VI11 with ALC650 Not Support SPDIF_IN

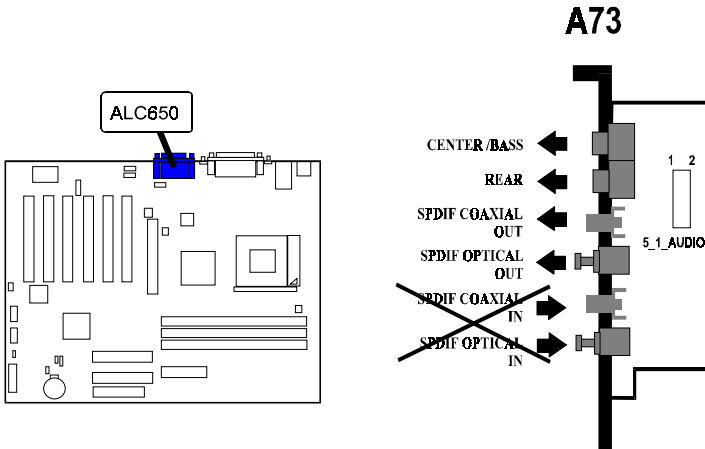
If your VI11 board has a label **ALC650** on the game port, the mainboard will not have SPDIF_IN features. The SPDIF_IN ports on the A73 card that mentioned in Page 2-17 Chapter 2 of this manual have no SPDIF_IN functions.
